Damascus Hills, Preliminary Plan Amendment, 12004080A

Damascus Hills, Preliminary Plan No. 12004080A:
Application to create seven lots for seven one-family detached dwellings, located at the end of Stanley Hills Way, approximately 1,100 feet south of the intersection with MD 108; 42.41 acres, RC Zone, 2006 Damascus Master Plan

Recommendation – Approval with conditions

Figure 7 – Forest Conservation Plan Annotated

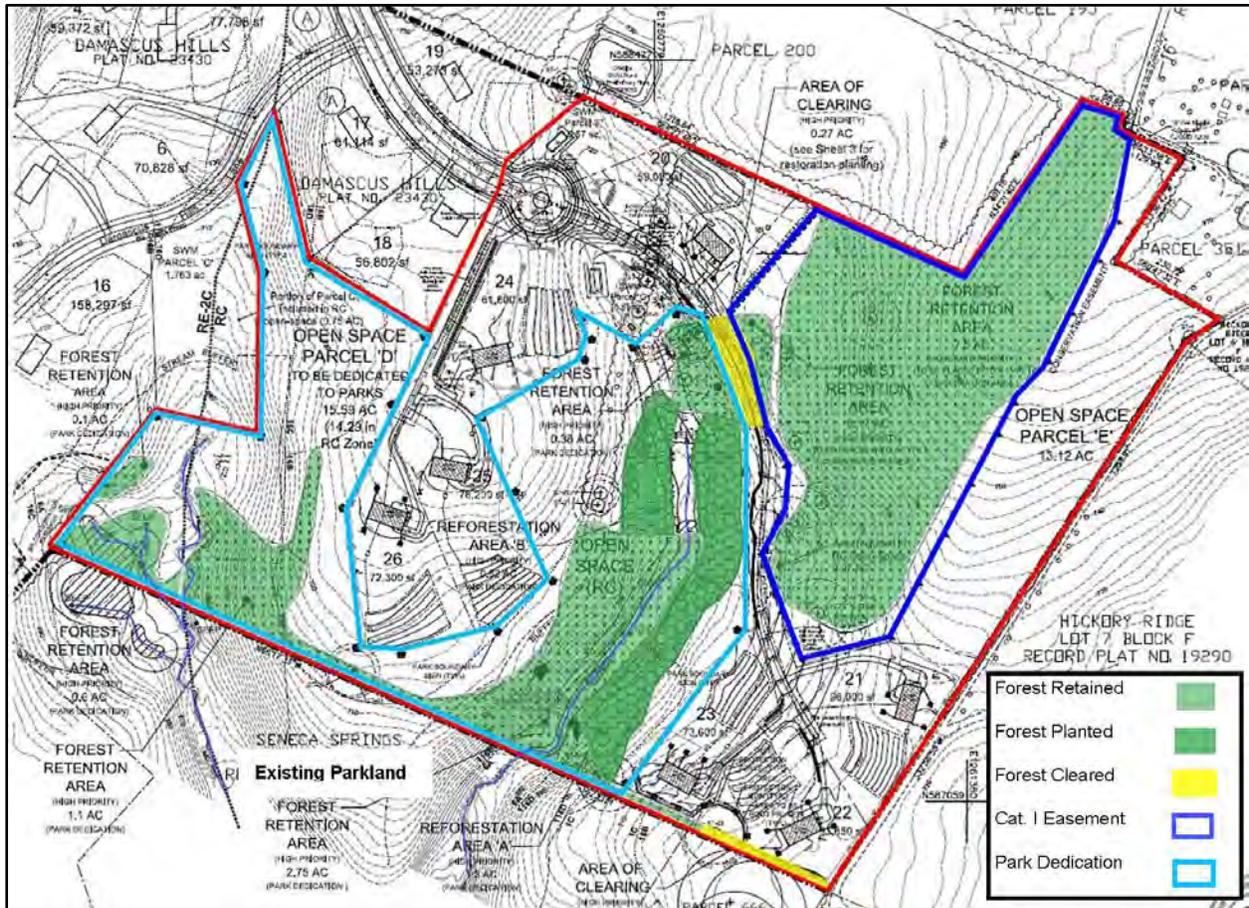
Staff is requiring the Applicant to mitigate for the loss of forest with on-site reforestation as required by Section 22A-12(f)(3). The clearing of the forest for the driveway creates a separation between the 7.5 acres of retained upland forest located north of the proposed driveway, and the larger forested area to the south of the driveway that is contiguous with the Great Seneca Stream Valley Park. In an effort to create canopy closure and minimize the fragmenting of the forest, the Applicant proposes to plant seventeen, 3-inch caliper, native canopy trees and six, 1-inch caliper, native understory trees in the area disturbed for the construction of the driveway. This will mitigate the effects of the forest clearing and the larger planting stock will accelerate the process of achieving canopy closure in this area. To further mitigate the loss of forest, the Applicant agrees to reforest an additional 1.02 acres of currently un-forested stream valley buffer area. These plantings are to meet the mitigation requirements of Section 22A-12(f)(3) and are in addition to the forest planting to meet the standard requirements of the forest conservation law.

The forest conservation worksheet for the RC-zoned portion of the property includes the proposed 0.40 acres of forest clearing, resulting in a reforestation requirement of 0.80 acres. To comply with the requirements of Section 22A-12(f)(2)(C) and 22A-12(f)(3), as described in the preceding paragraph, the Applicant proposed to achieve the required on-site forest requirements by retaining 11.9 acres of forest on-site, the maximum amount of forest possible that still allows access to proposed Lots 21, 22, and 23, in combination with providing an additional 1.02 acres of forest planting within the unforested stream buffer area. This results in a total of 11.9 acres of forest retention and 1.82 acres of forest planting, for a total of 13.72 acres of on-site forest, which exceeds the 12.51-acre minimum on-site forest requirement (Figure 7).

Figure 8 - Variance Trees

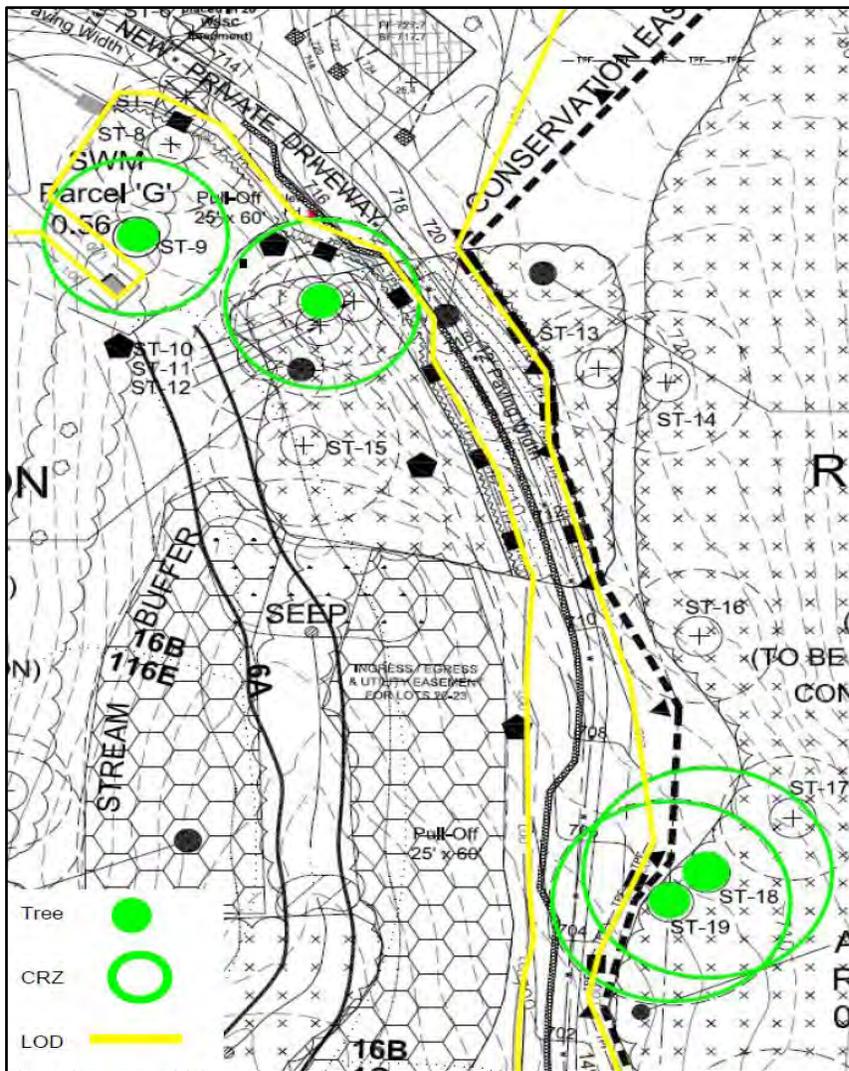
Variance Request - The Applicant submitted a variance request in a letter dated May 5, 2016, for the impacts/removal of trees (Attachment 8). The Applicant proposes to impact, but not remove, four (4) Protected Trees that are considered high priority for retention under Section 22A-12(b)(3) of the County Forest Conservation Law. None of the trees subject to this provision will be removed. Details of the Protected Trees to be affected but retained are shown graphically in Figure 8 and listed in Table 2.

PRELIMINARY PLAN
DAMASCUS HILLS
Montgomery County, Maryland

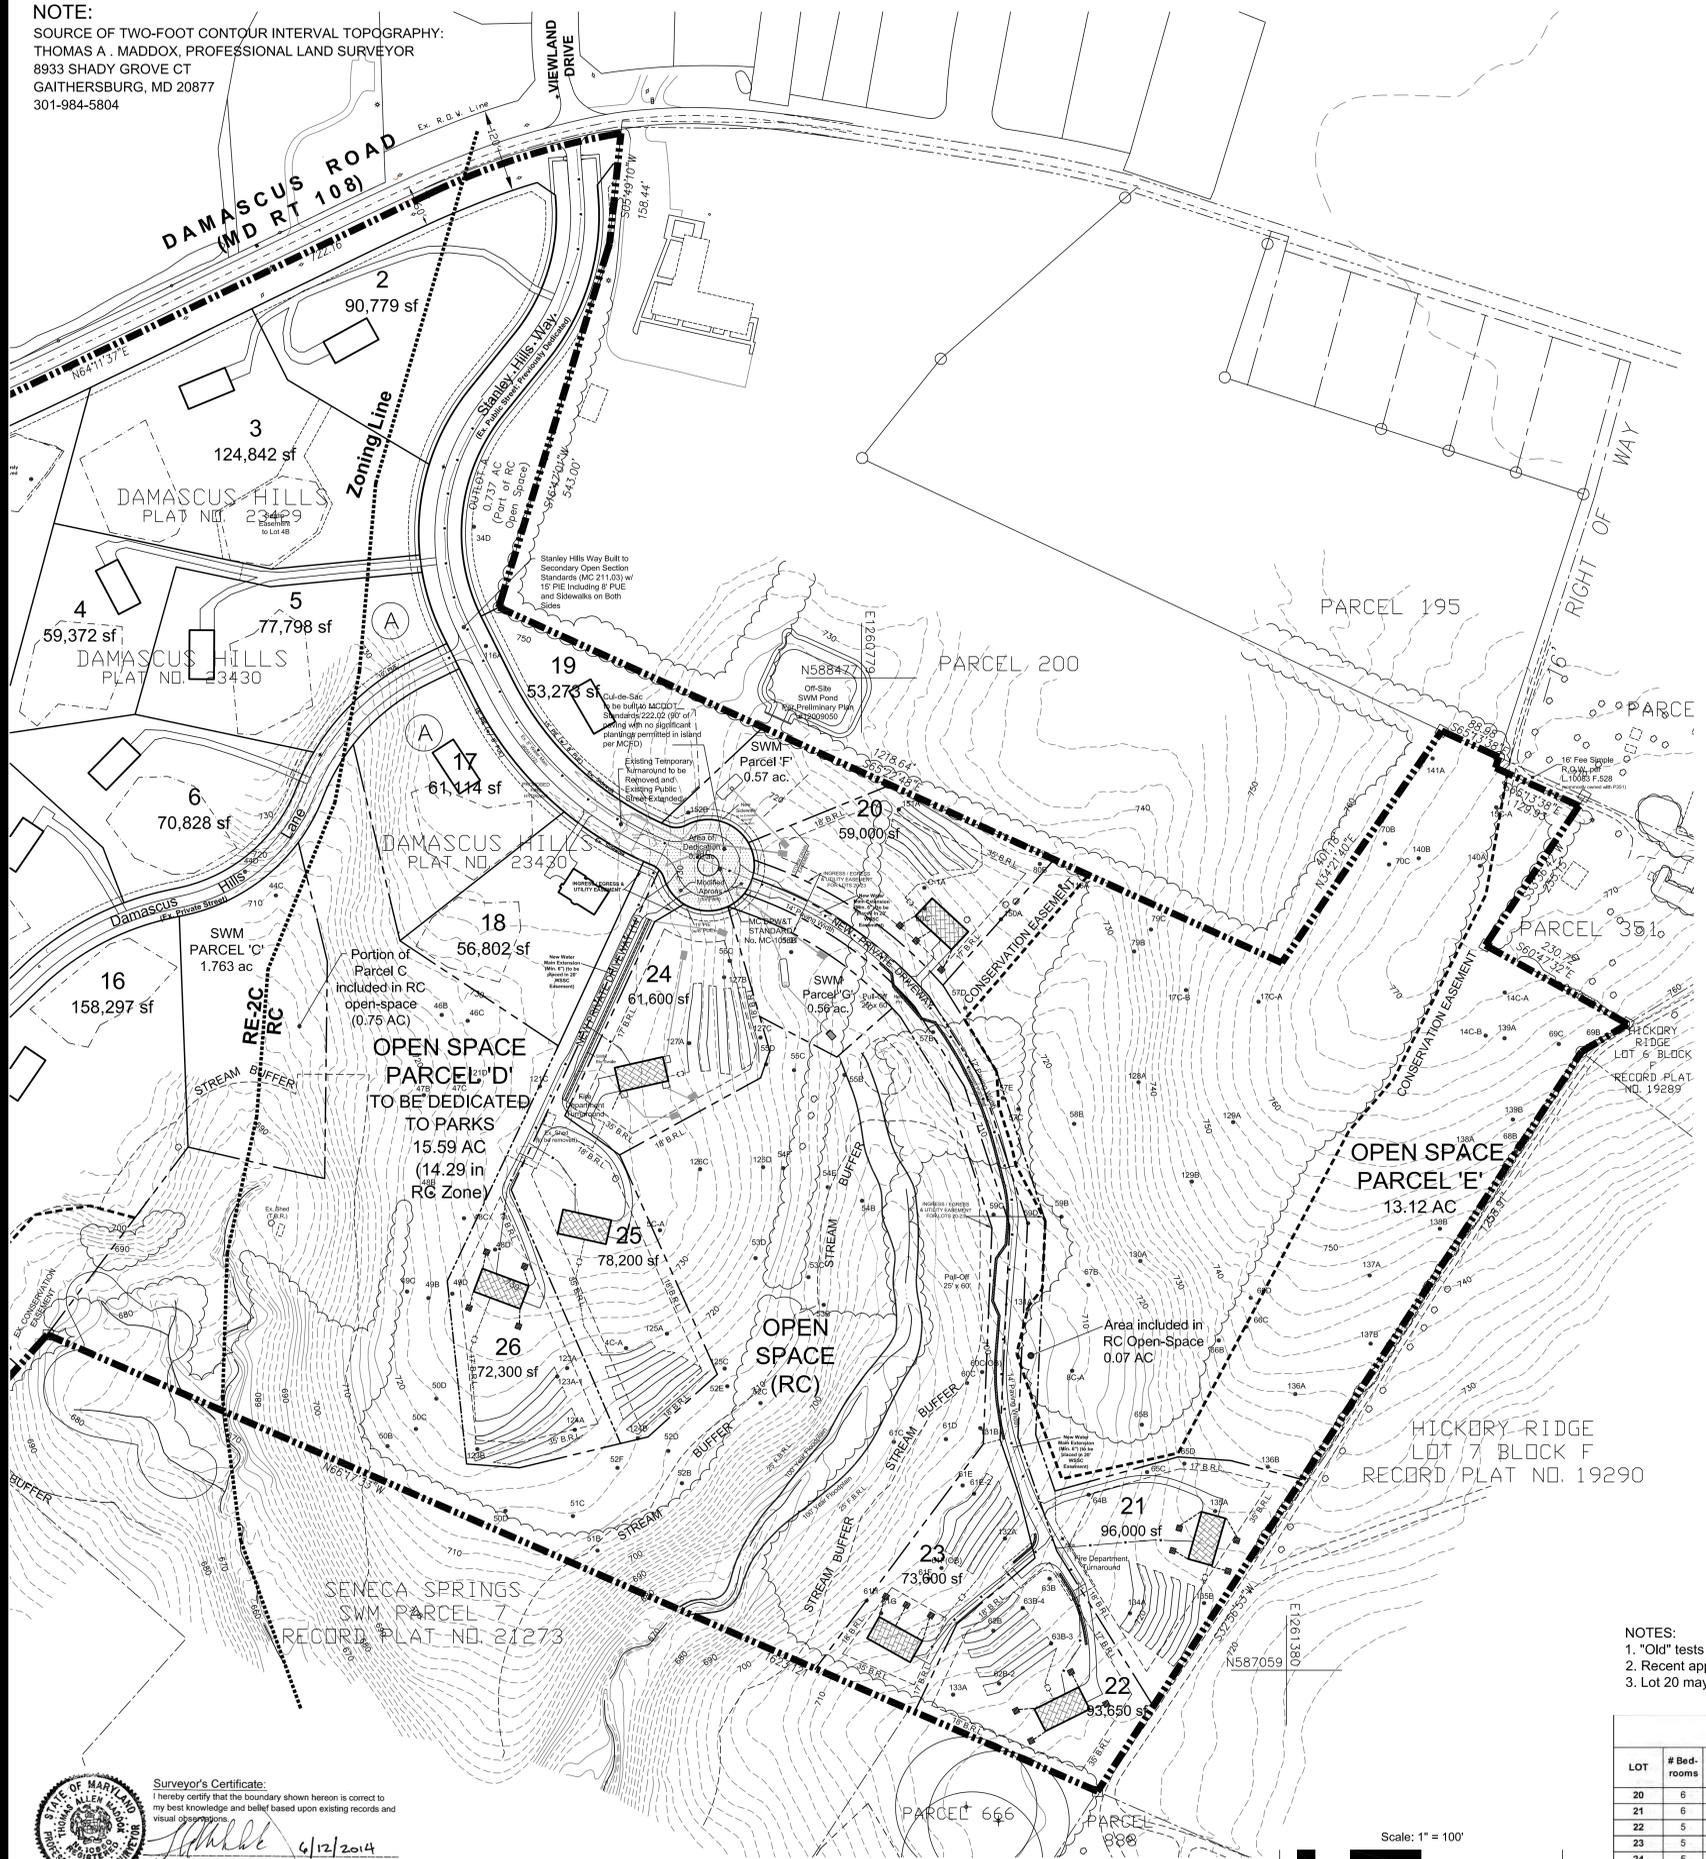
NOTE: the notes on the preliminary plan indicate a fifteen (15) foot wide PIE and an eight (8) foot wide PUE. These notes are incorrect; the PIE should be seven (7) feet wide with a fifteen (15) foot wide overlapping PUE. These notes should be corrected prior to approval of the Certified Preliminary Plan.
